SITE SUPPLEMENTAL INSTRUCTION

PROJECT: Forestside Estates
Attmar & Palleschi Drive
Brampton, Ontario

SITE SI NO. E-6

PURPOSE: Revised as per Arch SI A01 and Mech S SI M-2.

TITLE: **PARKING LEVEL PART A ELECTRICAL**

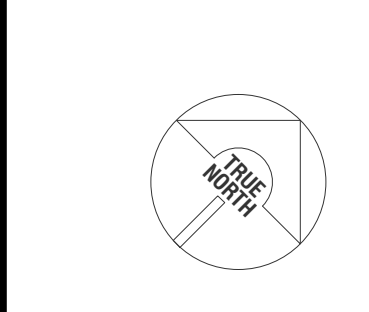
1.0 Reference Drawings E-2A/2B (Parking Level - Electrical) Issued

1.1 Revise: Electrical layout as shown, all elevator sump pump location revised.

TITLE	2ND FLOOR PLAN ELECTRICAL		
PROJECT	BRAMPTON STACKED FORESTSIDE ESTATES		
	ATTMAR + PALLESCHI DRIVE BRAMPTON, ONTARIO		
DRAWN	CHECKED	SCALE	
SP	MG	1:50	
DATE	PROJECT	DRAWING	
MAY, 2019	18-017	E-4	
		OF	16

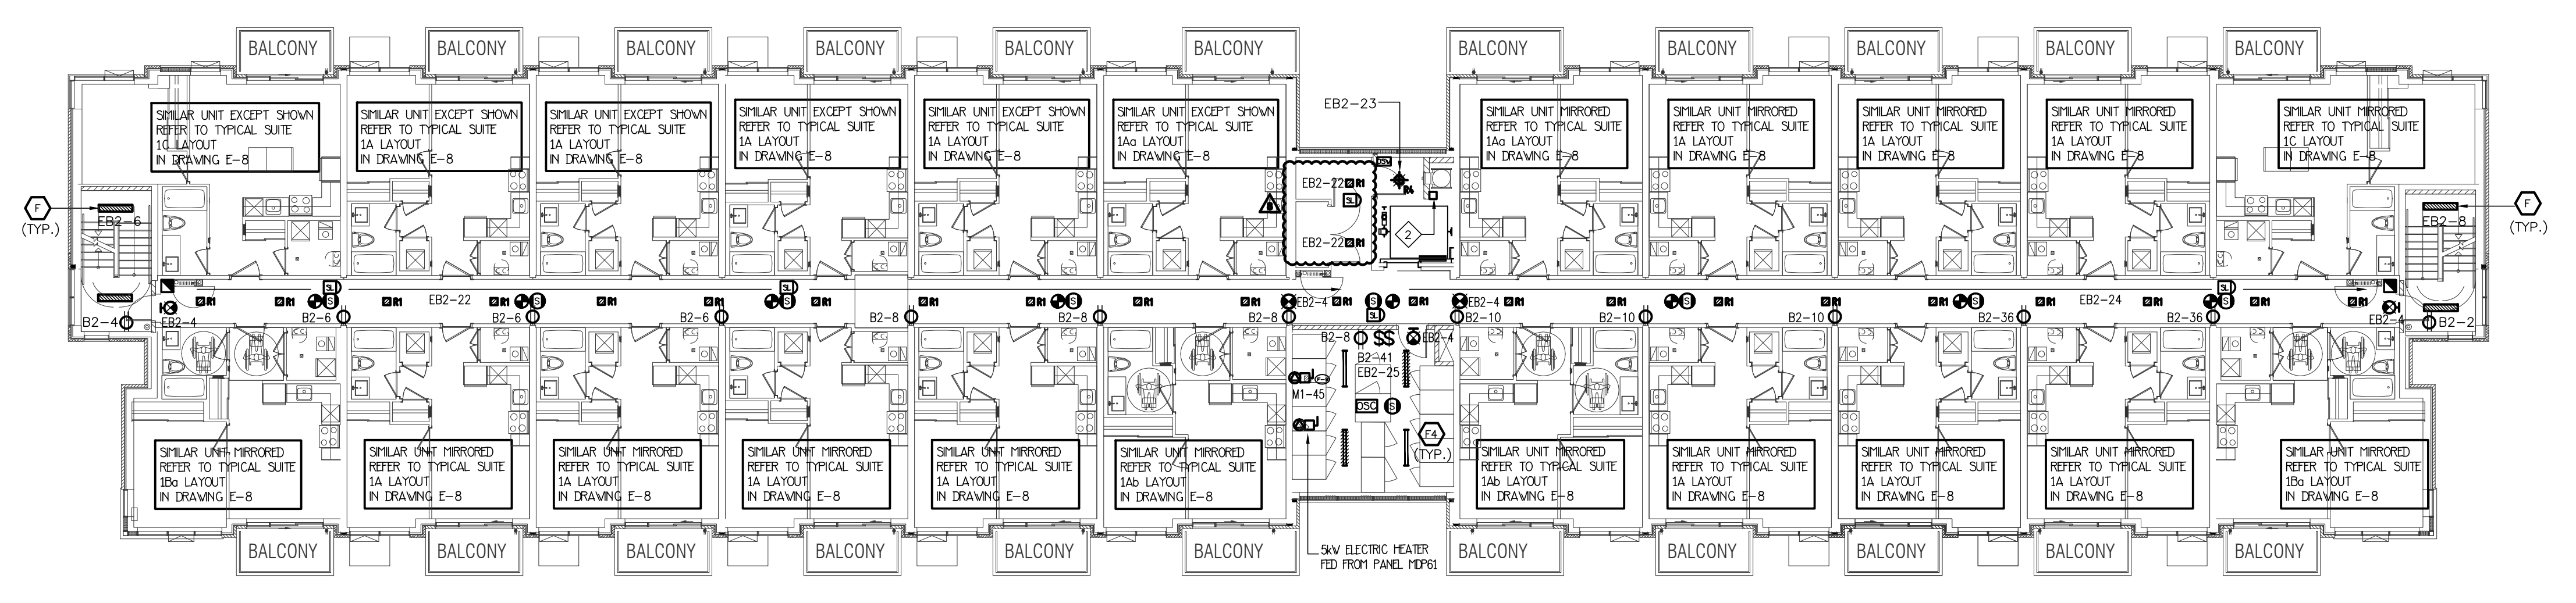
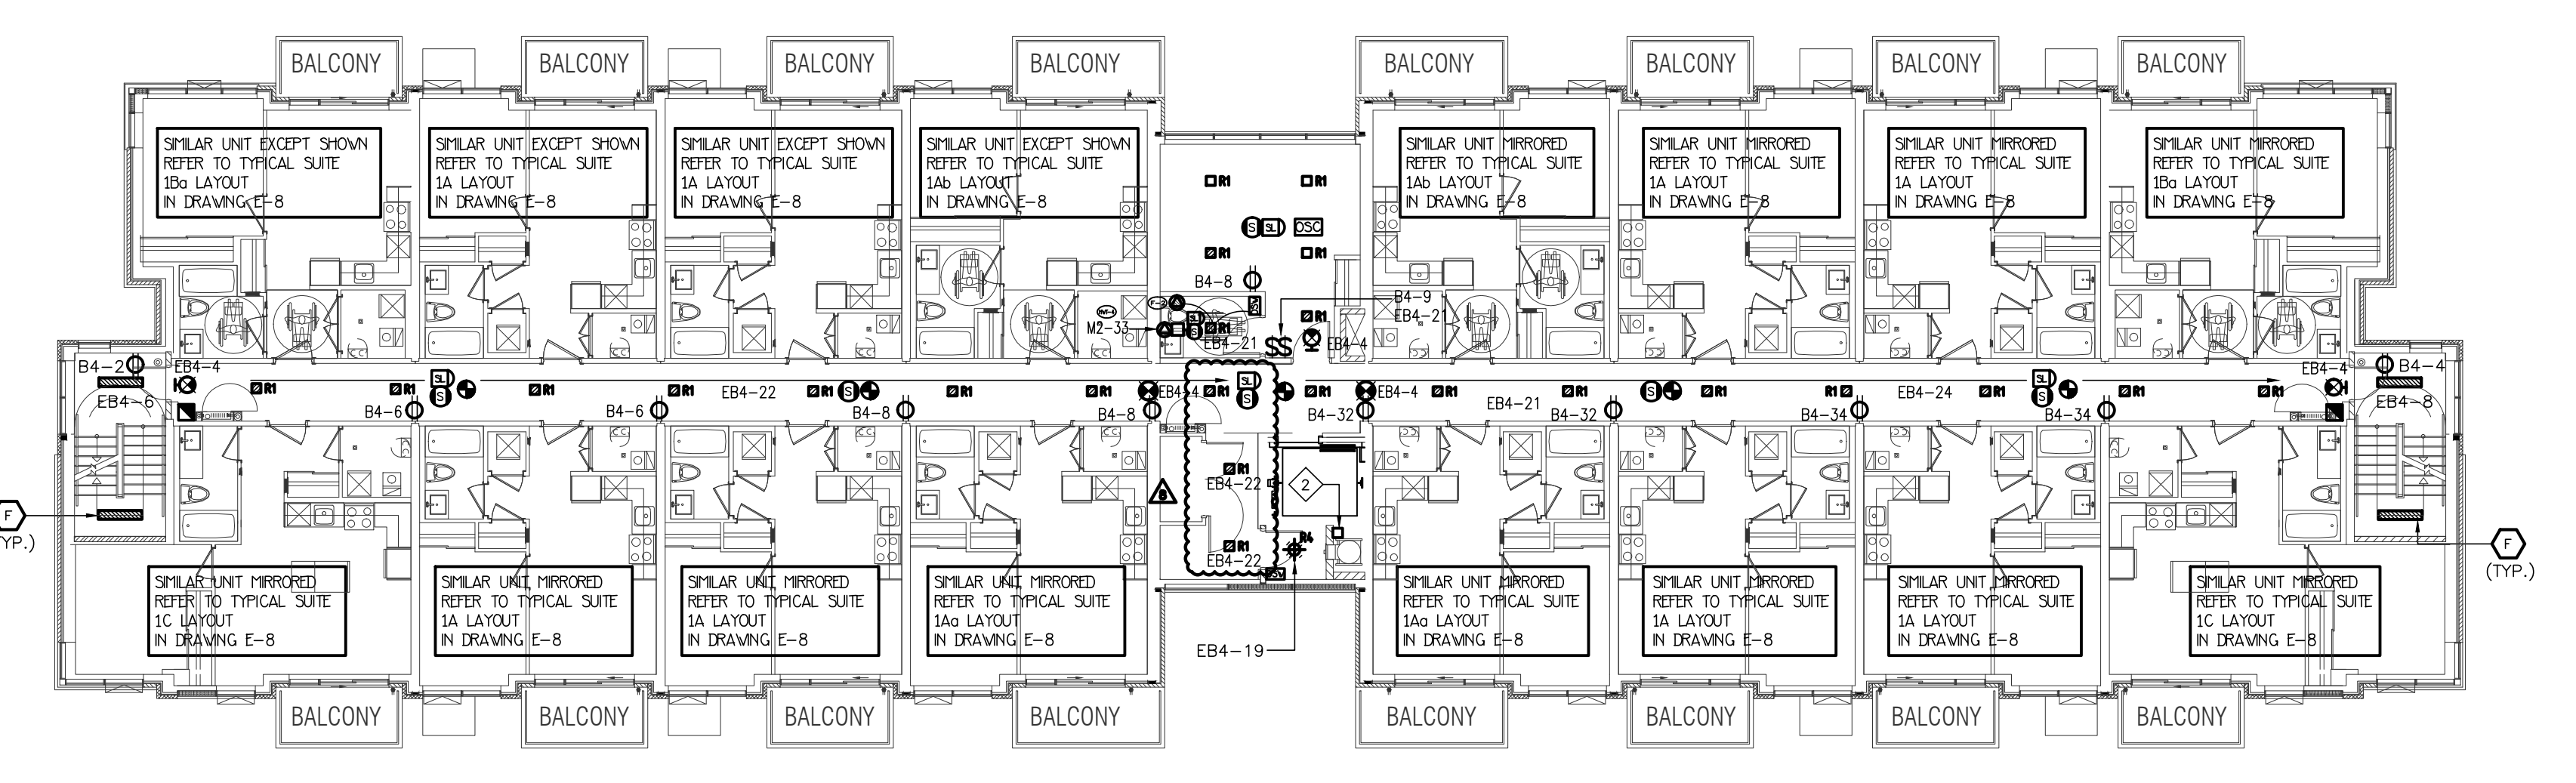
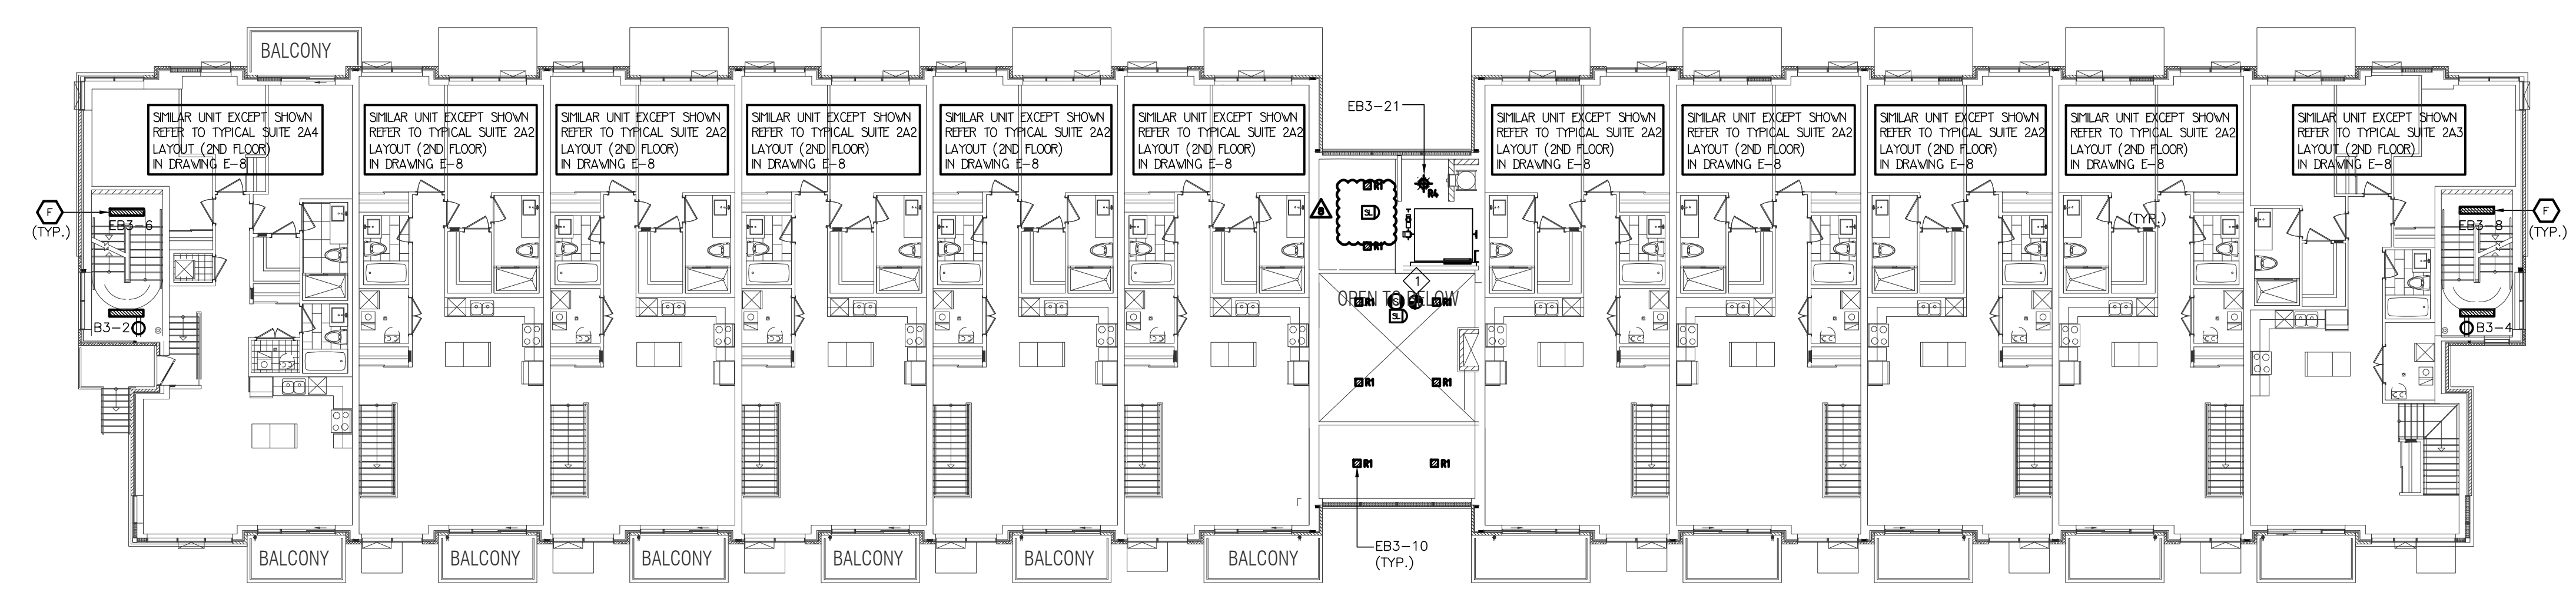
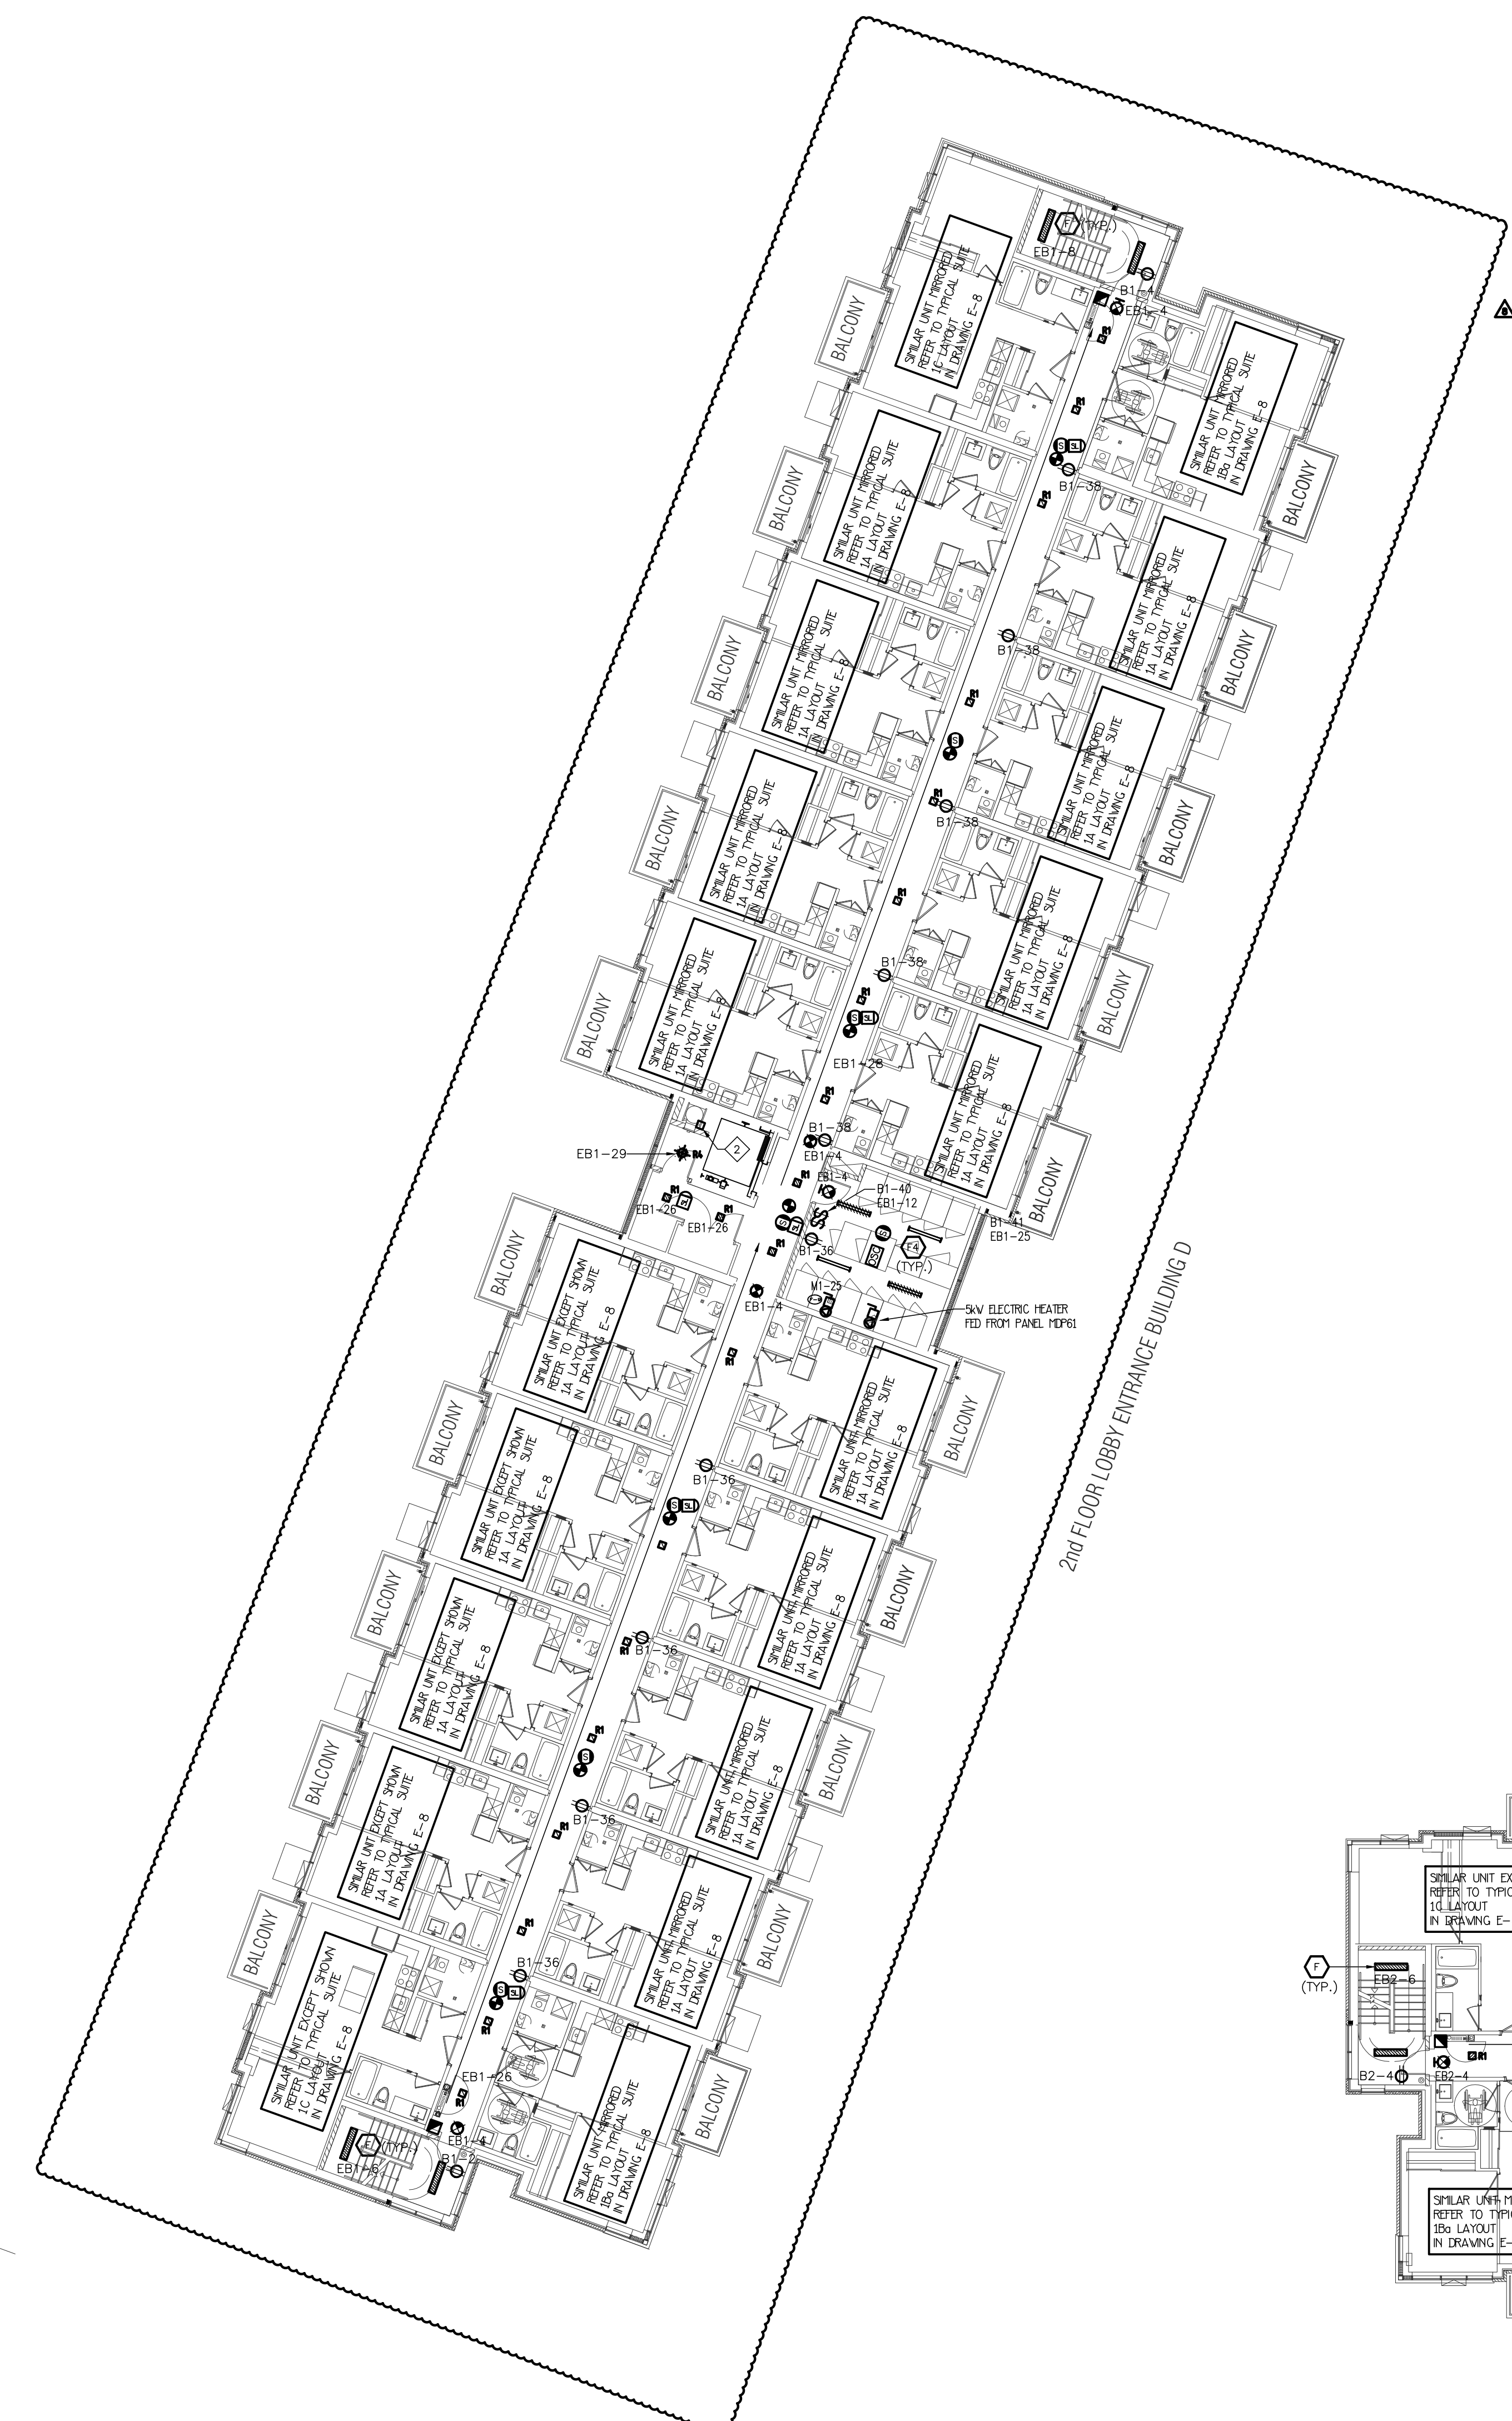
2.0 Reference Drawings E-3 (Ground Floor - Electrical) Issued
E-4 (2nd Floor – Electrical)
E-5 (3rd Floor – Electrical)

2.1 Revise: Electrical layouts for building D and clarification as shown.
